**City of Bellevue
Development Services Department
Land Use Staff Report**

Proposal Name: **Li Backyard Landscaping**

Proposal Description: Critical Areas Land Use Permit for residential backyard landscape improvements adjacent to the West Tributary, a Type F fish-bearing stream. The proposal would replace timber landscape walls with landscape bricks, grade to level the backyard, construct a footbridge, and enhance the stream buffer on the east and west sides of the creek.

File Number: 19-102730-LO

Figure 1 – Site Plan

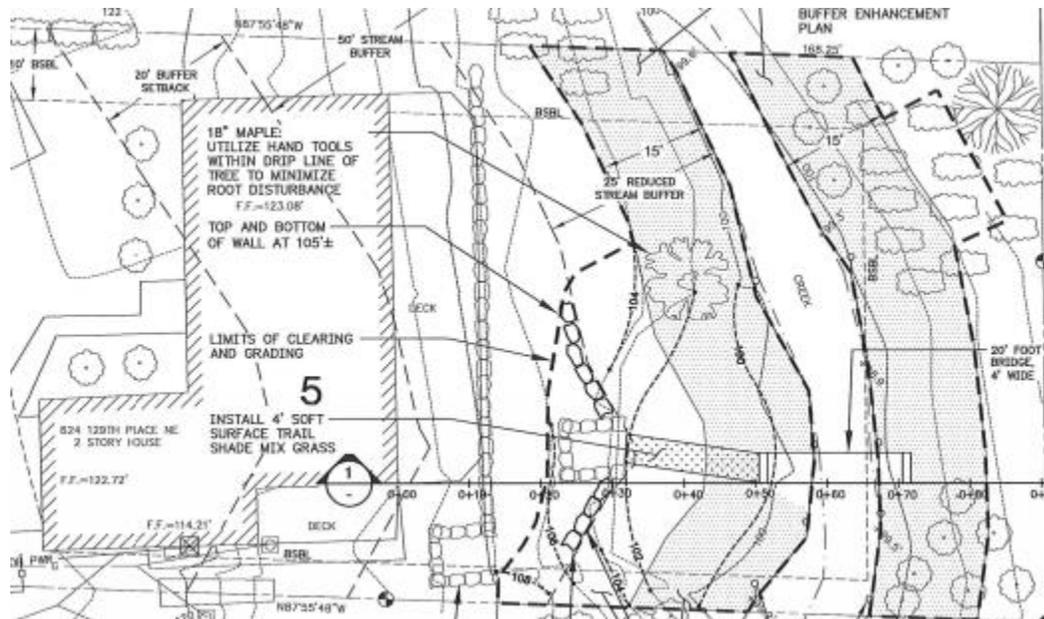
VII. Changes to Proposal Due to Staff Review

- Applicant provided clarification on the 100-year floodplain elevation on the subject site.
- Plans were revised to include details of the footbridge design.

- Plans were revised to remove all landscape walls installed within 25-feet from the OHWM of the creek.
- Conceptual mitigation plan was revised to include native planting enhancement on both the east and west sides of the stream (15-foot width), increasing the enhancement planting area from 260 SF to 2,030 SF.

- Pacific Rhododendron (not a riparian plant specie) was removed from the planting plan.
- The Conceptual Planting Plan was revised to provide on-center plant spacing consistent with the City's *Critical Areas Handbook*.

- Plans were revised to show a 4-foot wide trail to the proposed footbridge.
- Plans were revised to reduce the height of a segment of landscape wall encroaching into the 5-foot side yard structure setback along the south property line to a maximum height of 30-inches.

- 3. Fill and Walls in Critical Area Buffer:** All fill and block walls placed within the 25-foot stream buffer must be removed. The area must then be regraded to previously existing grade.

- 4. Footbridge Decking Materials:** To avoid water quality impacts from leaching of wood preservatives, the wood planks for the bridge decking shall be a non-toxic wood product approved for use in aquatic environments.

Figure 4. Existing Conditions (Post-Landscaping) with Stream Buffer and Structure Setback

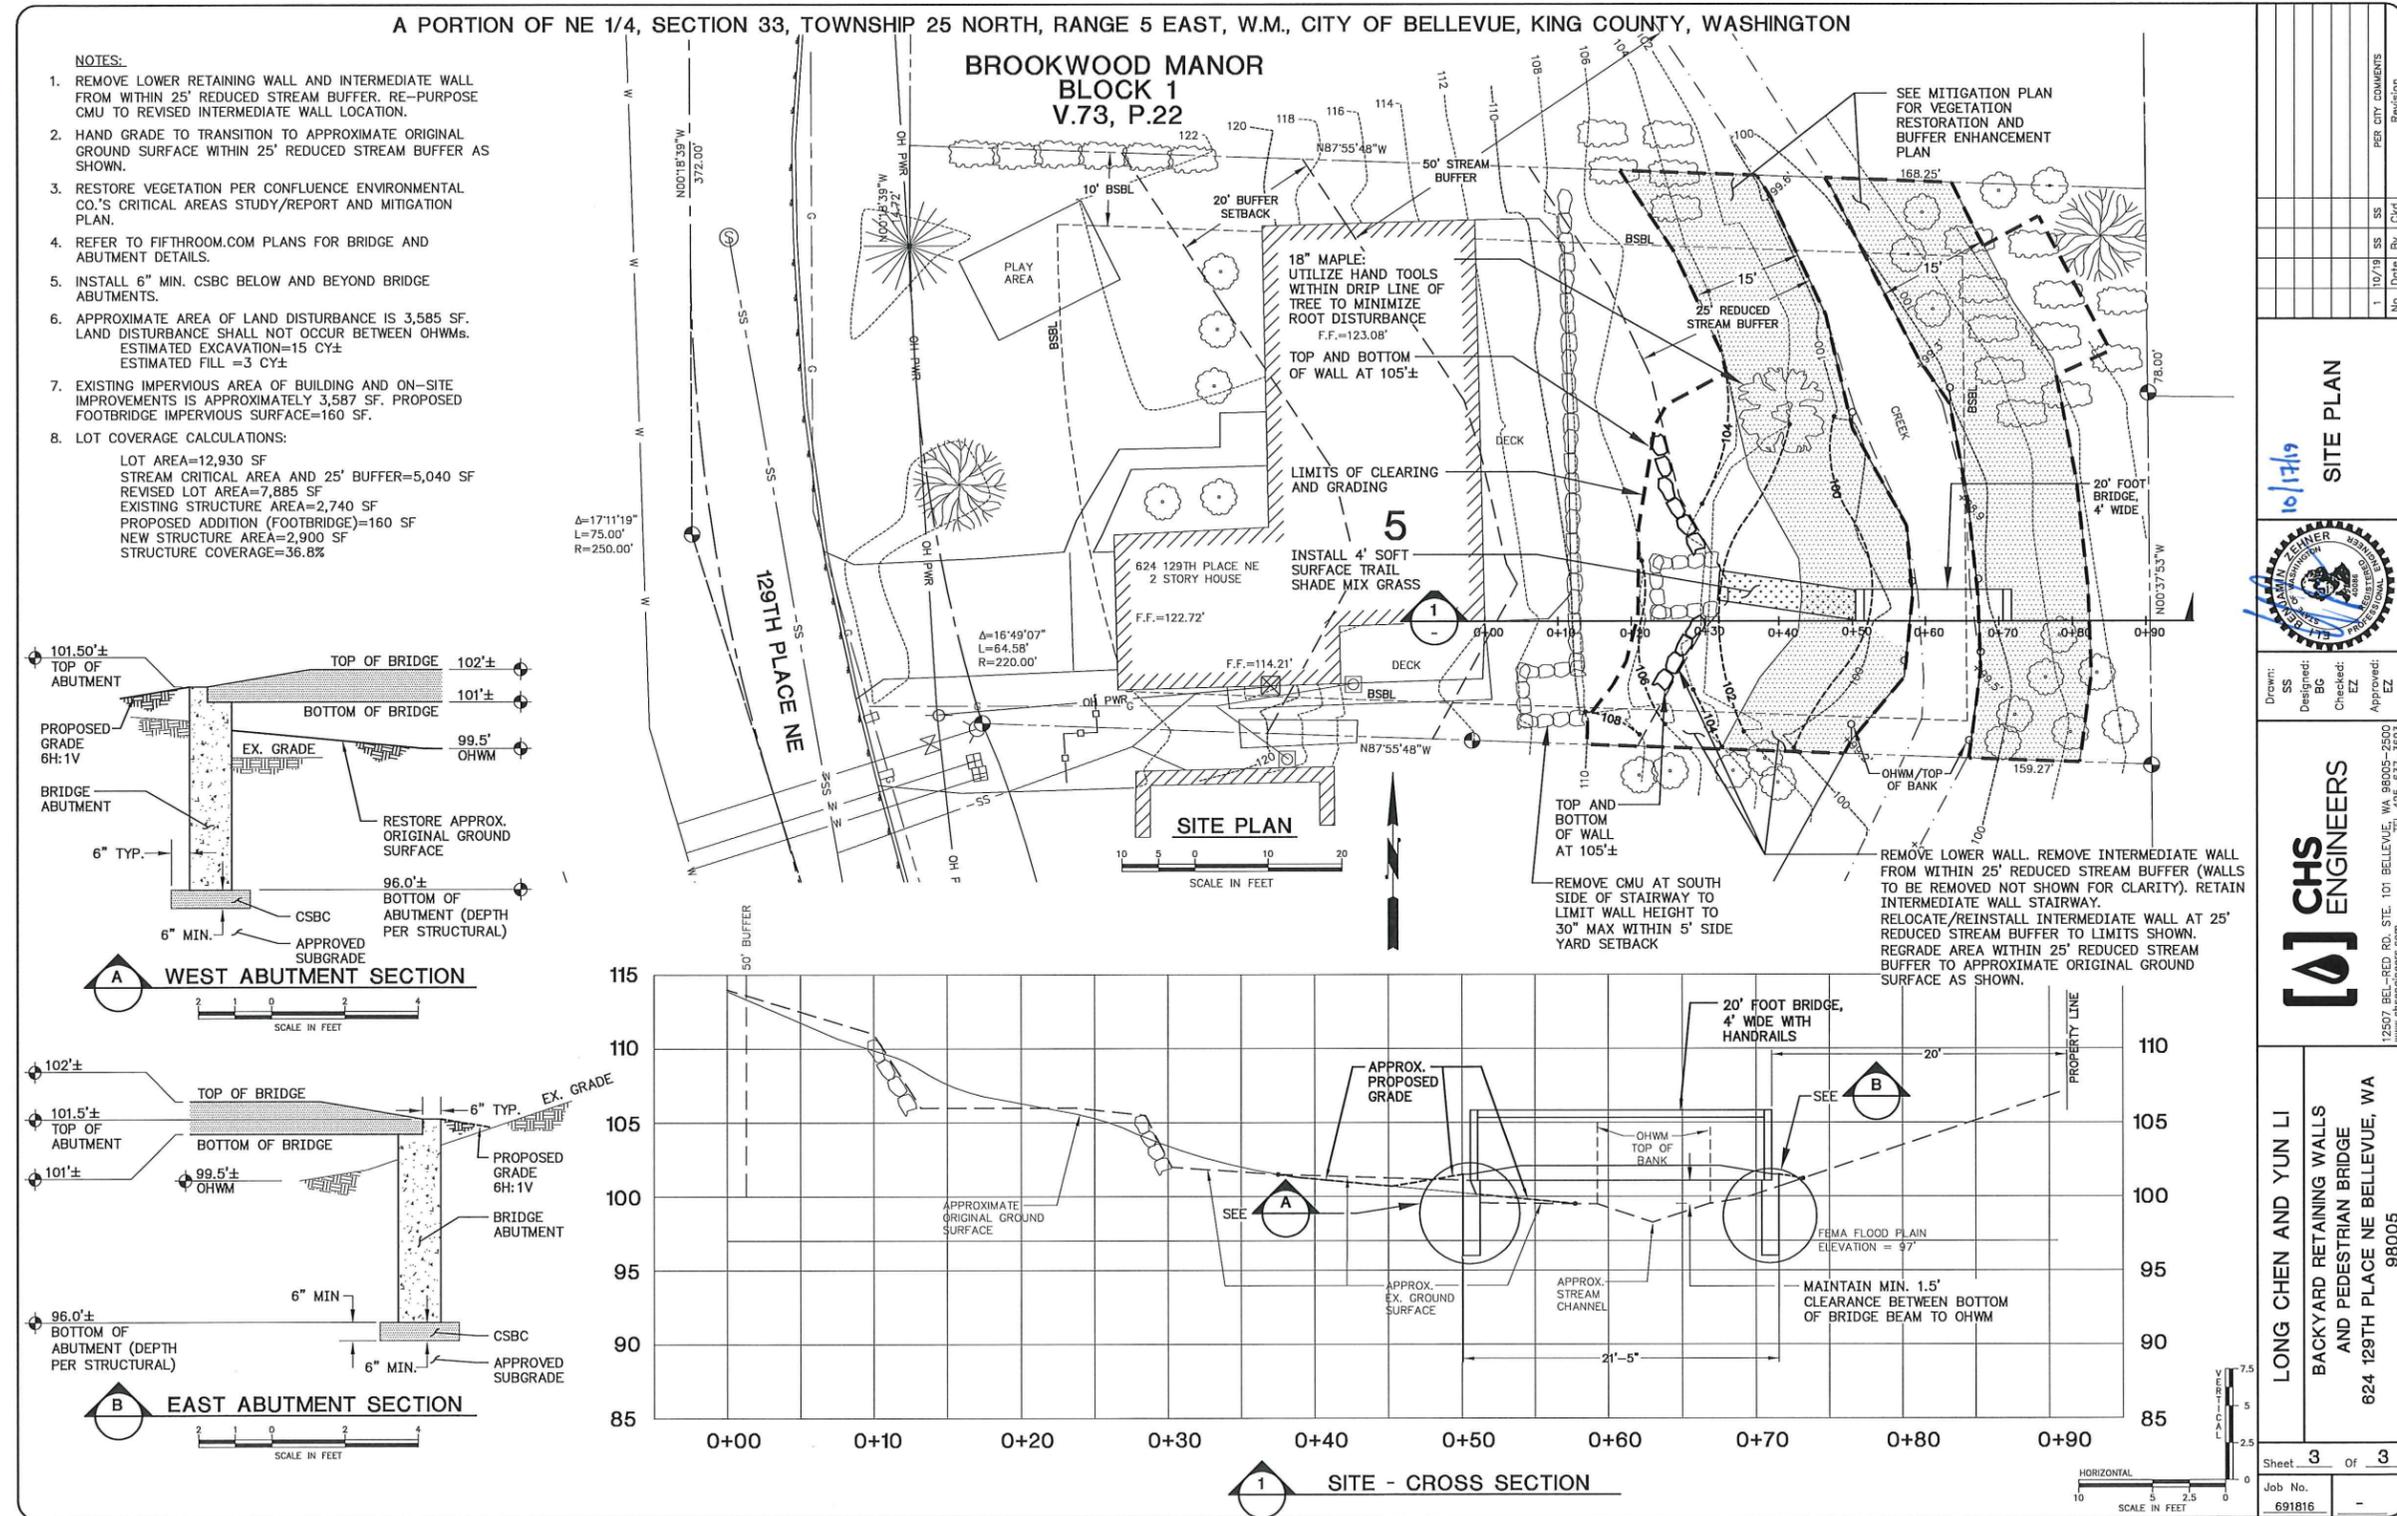
The site is located in the R-3.5 zoning district. The plans demonstrate conformance with zoning dimensional standards. A segment of the installed landscape wall encroaches into the 5-foot side yard structure setback along the south property line. The applicant proposes to reduce the height of this wall segment to a maximum of 30-inches above existing grade. Conformance with all zoning requirements will be verified as part of the required Clearing and Grading Permit review. **See Section X for condition of approval regarding Clearing and Grading Permit Required.**

Clearing and Grading review requires a condition that all fill and block walls placed within the 25-foot stream buffer must be removed and the area must then be regraded to the previously existing grade. **See Section X for condition of approval regarding to Fill and Walls in Critical Area Buffer.**
